DSRFY2020-14 The River at Parkway Apartments

Design Modifications Narrative

SHEET NO.
A2.0

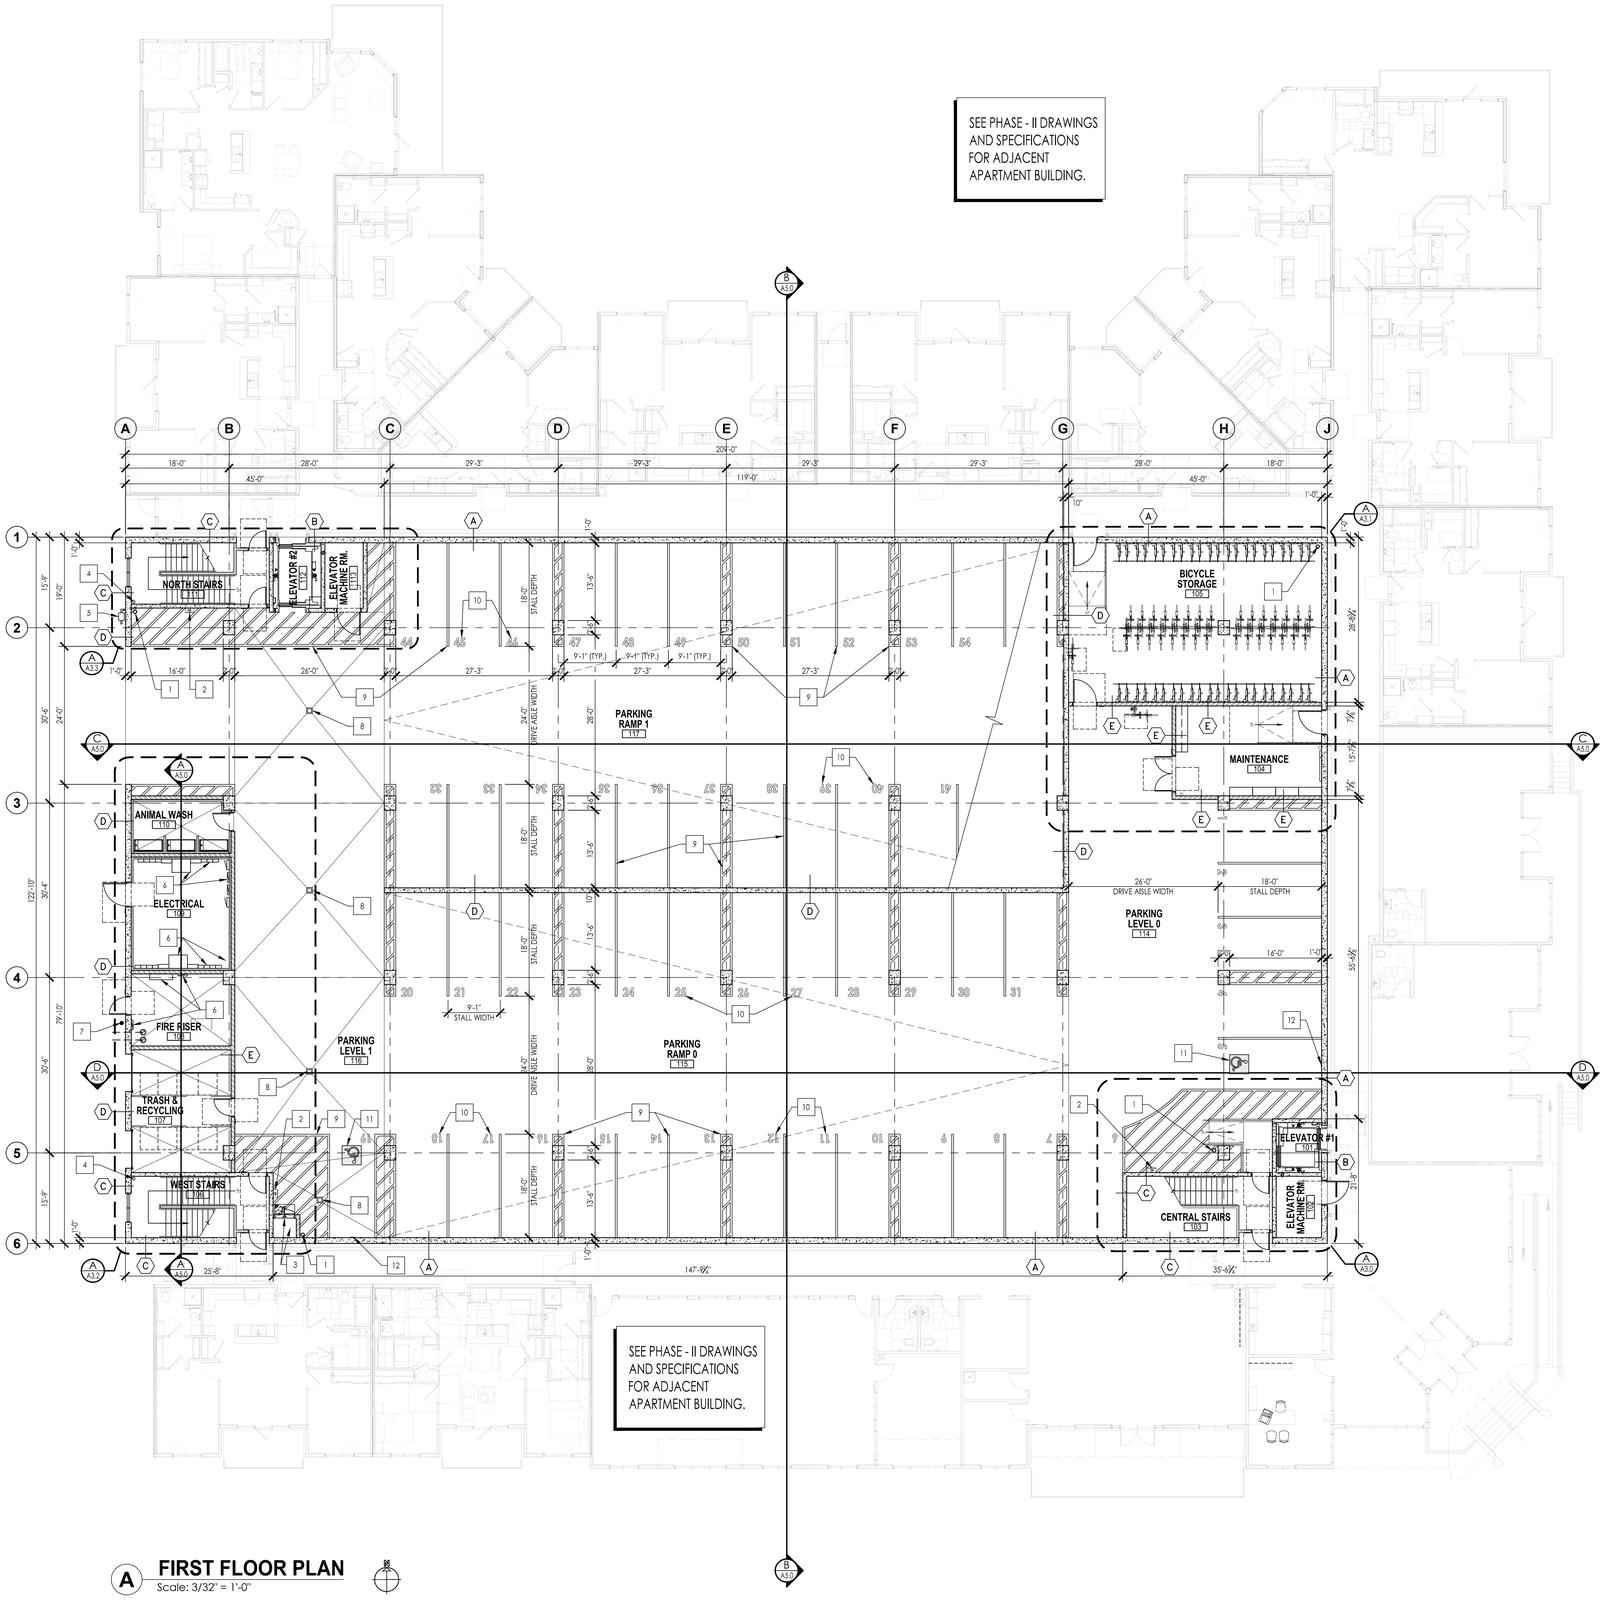
1. The number of parking spaces has been revised to 136 spaces in the parking garage and 9 spaces on 43rd Street for a total of 145 spaces.
2. The exterior apartment balconies have been revised to make all the balconies the same depth, eliminate the angled columns and projecting roofs above.
3. The apartment windows have been changed from aluminum to vinyl.
4. The horizontal siding has been changed from metal to fiber cement.

1. Parking Spaces: During the design development process the design was submitted to the Owner's institutional investors for review. The investor's analysis concluded that the project as originally submitted was overparked which made it non-viable as an investment. Their analysis was based upon national vehicle ownership and parking trends for the target market for this type of apartment project and parking provided at local comparable properties. As documented in the attached Parking Trends Study, 64% of households in this type of housing own only one vehicle or no vehicle at all. The average number of parking spaces provided for new apartment construction nationally is less than 1.5 spaces per unit. For mid-rise apartment such as this the national average number of parking spaces provided is 1.25/unit.

The partial third floor parking deck and ramp was eliminated to reduce the number of parking spaces. Some storage units were removed on lower levels to gain back spaces. This also reduced the height of the west elevation of the parking garage by one story. Because of the reduction in parking garage levels we were able to add windows to the 3rd floor corridor of the apartments above. We believe this is an improvement to both the interior and exterior of the building.

C EAST ELEVATION - 43rd STREET

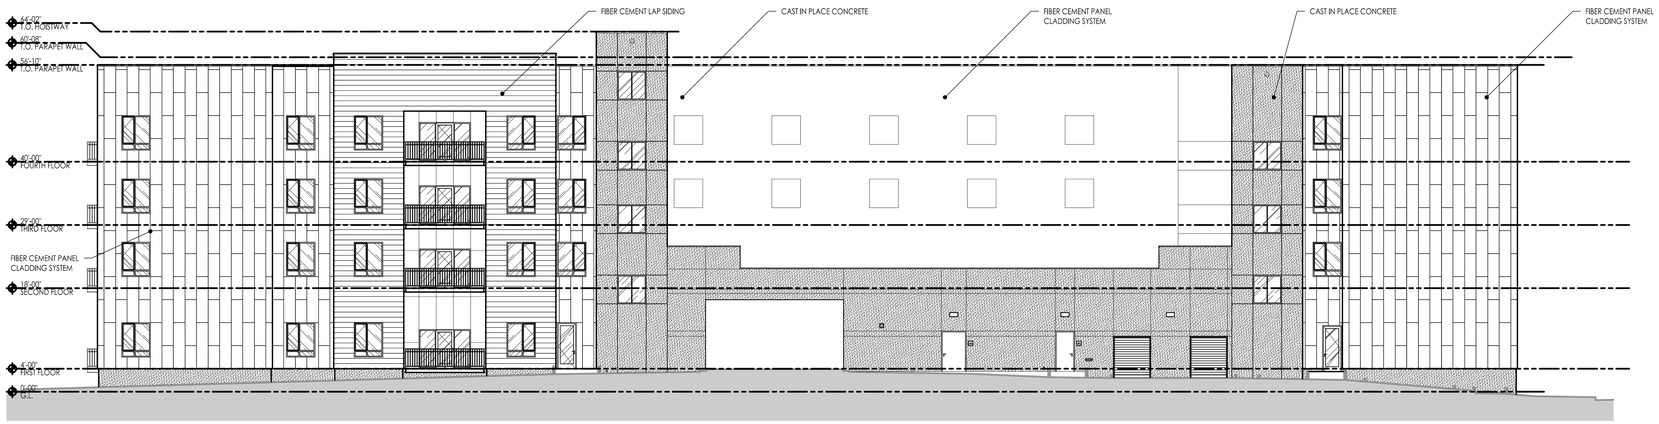
2. Balconies: After design review approval we discovered that some of the stepped balconies and balcony roofs were projecting into the setbacks further than is allowed by the zoning ordinance. To make these balconies compliant with have reduced the projection of the upper balconies to match the depth of the first floor balconies. Since the balconies are now all the same depth the angled columns and sloped projecting roofs were no longer appropriate and have been eliminated. To maintain the consistency of the design this change has been made around the entire building. We believe the overall design of the building and façade is not adversely affected by this change and that the integrity of the massing and articulation remains intact as is illustrated by the attached renderings.

3. Windows: The original proposed aluminum windows have proven to be outside of the owner's budget and may not be available to meet the project timeframe. The windows have been changed to a more standard vinyl window that are typical for this type of project. We do not believe the change will have an impact on the general appearance of the exterior design.

4. Horizontal Siding: We are proposing that the horizontal metal siding originally contemplated for portions of the exterior apartment cladding be replaced with horizontal fiber cement siding. The vertical panels of the original design are fiber cement and having both products by the same manufacturer will make detailing, waterproofing and obtaining a manufacturer's warranty much simpler and more practical. There was also a concern with potential damage to the metal siding in the balcony alcove areas where it would be susceptible to denting and scratching by tenants. The fiber cement siding is durable and relatively easy to repair or replace. We believe we can achieve a look very similar to the approved design with the horizontal fiber cement lap siding.
